The text reproduced below was prepared by the Task Force on Substitutes and Retrofits (TF SR) to modify GRE/2018/40, where the information for the 24V version was missing, and to implement editorial corrections. GRE/2018/40 was adopted by GRE during its 80th session as part of a package which also includes amendments to UN Regulation No. 128.

Sheet PY21W/LED/1, amend to read:

Figure 1
Main drawing

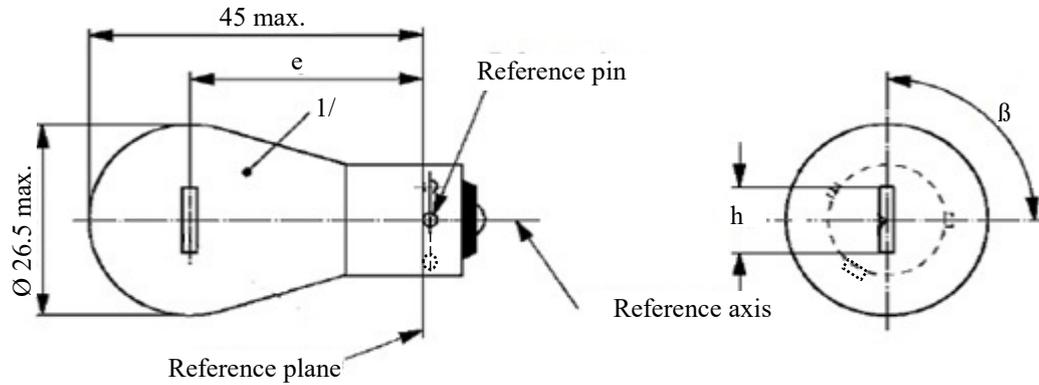
4. Removing tolerance values of angle β

While the category sheet of the PY21W filament light source contains a rotational tolerance of $\pm 15^\circ$ for the angle β (see “screen projection requirements” of sheet P21W/2), this rotational tolerance has been included in the dimensions of the box system of the corresponding LED Substitute light source PY21W/LED (see sheet PY21W/LED/2) and the tolerances of angle β has no meaning anymore.
